NUCLEAR REGULATORY COMMISSION

Title: 662nd Meeting, Advisory Committee on Reactor Safeguards (ACRS)

Date: April 4, 2019

ACRS Full Committee Presentation: NuScale Chapter 9, Auxiliary Systems

Pool Liner

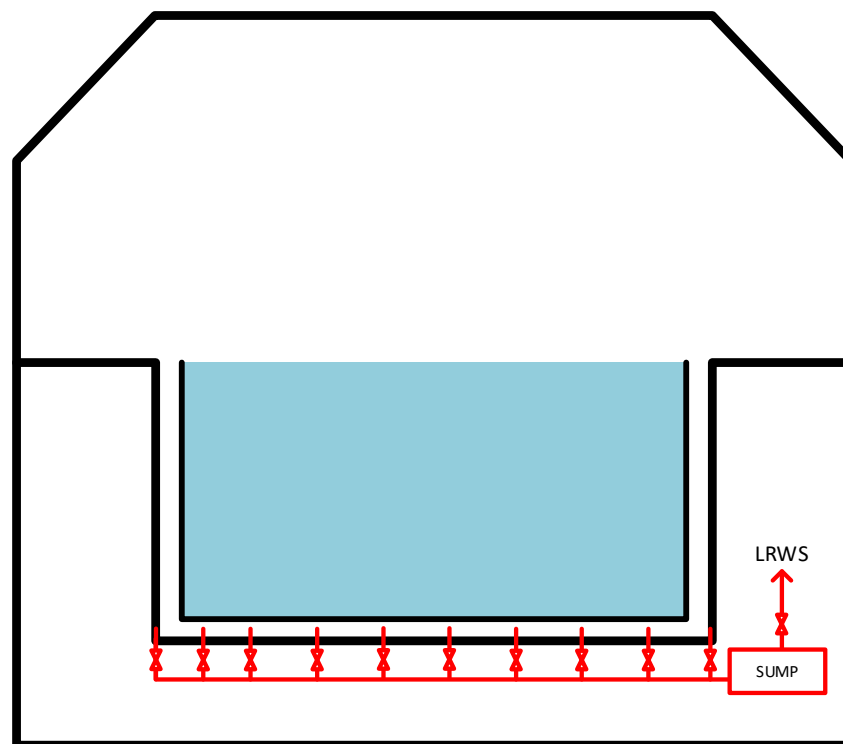
22 I will make one more comment and stop.
23 The most distant liner on your safe load path from
24 your refueling equipment will see 120 module moves
25 in 60 years, 30 per bay, left and right, is 120 in

1 combined output of all of the sumps that are
2 monitoring? If say you are 26 gallons a minute
3 combined sump, are you going to have a tech spec
4 that says at this level, even though we can maintain
5 the level because we've got 7 million gallons and
6 the level change is very easily controlled, we will
7 do something to the plant because we have something
8 going on in the liner that is adverse to safety?

- Liner Functions:
 - Protect concrete from the borated pool water.
 - Collect pool leakage and direct to sumps.
- Seismic Category I
- High sump level alarms in control room

Reactor Pool Mixing

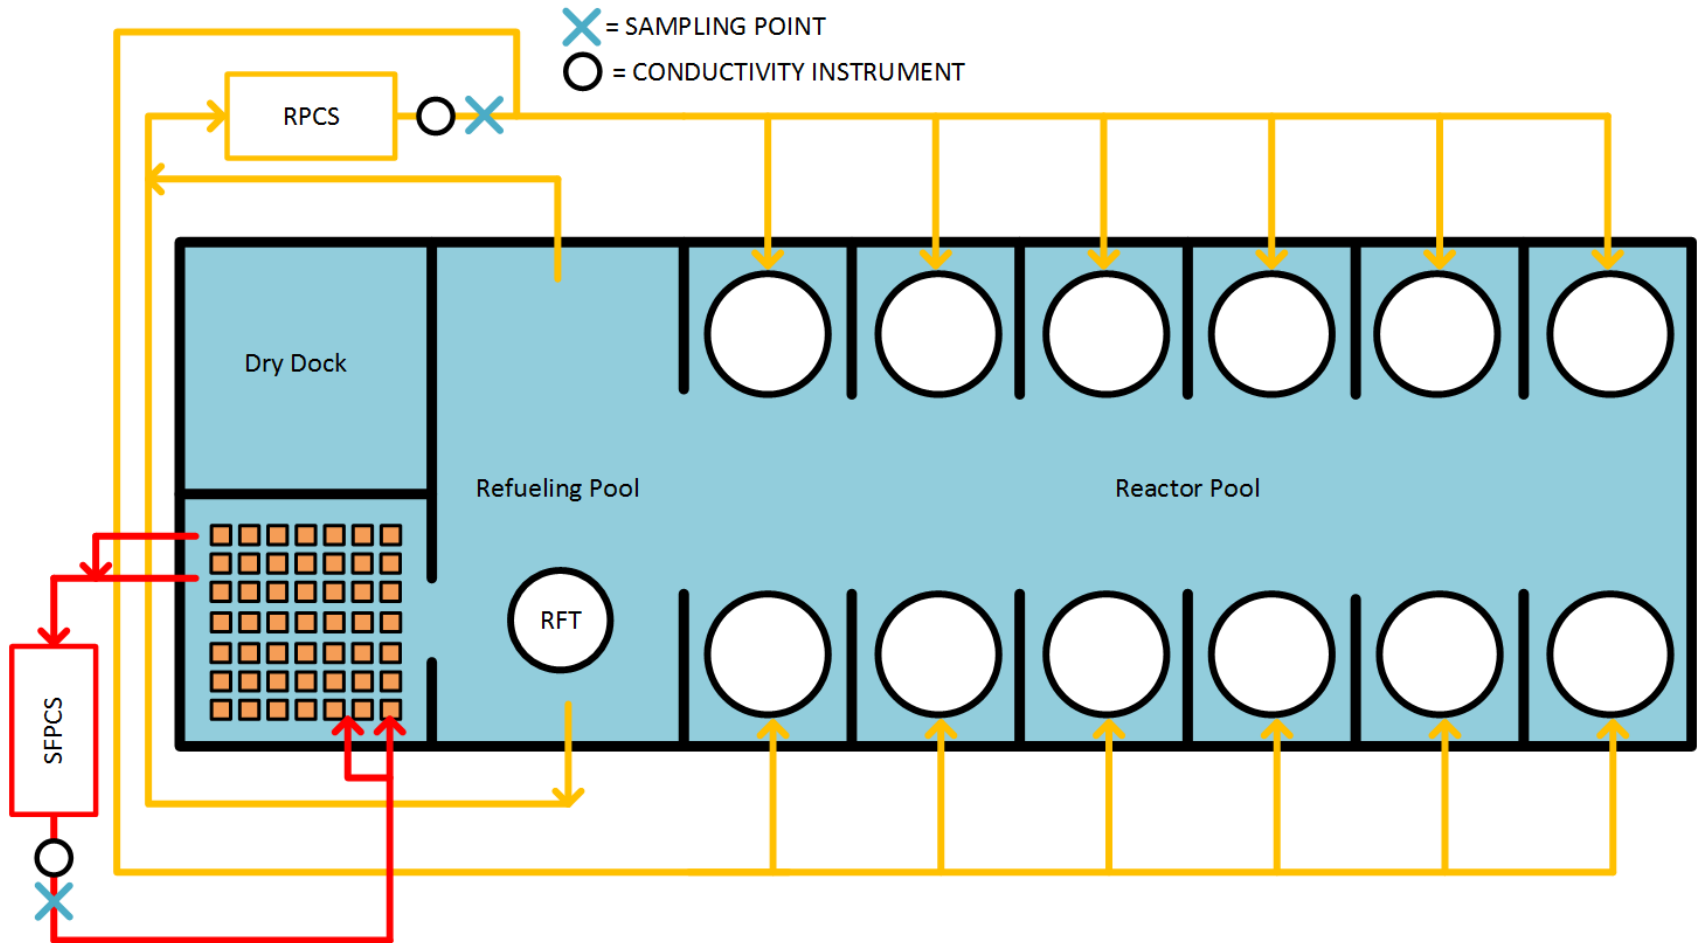
19 MEMBER REMPE: So to add to that, during
20 our subcommittee meeting, this question was asked by
21 Member Bley. And I believe that you, Scott,
22 mentioned -- said that it's not specified yet where
23 you're sampling. And so now you've given us a slide
24 that talks about where it is sampled.

- Spent Fuel Pool Cooling System
 - 2x 1250 gpm pump & heat exchanger trains
- Reactor Pool Cooling System
 - 3x 1250 gpm pump & heat exchanger trains
- Combined minimum operating flow (1 SFPCS / 1 RPCS)
 - 3.6 Million gallons / day (~7 Million gallon pool)
- Sample points on discharge of RPCS, SFPCS, and PCUS
- Conductivity monitors on outlet of RPCS, SFPCS, and PCUS
 - Conductivity mismatch between systems could indicate a difference in boron concentration between pools
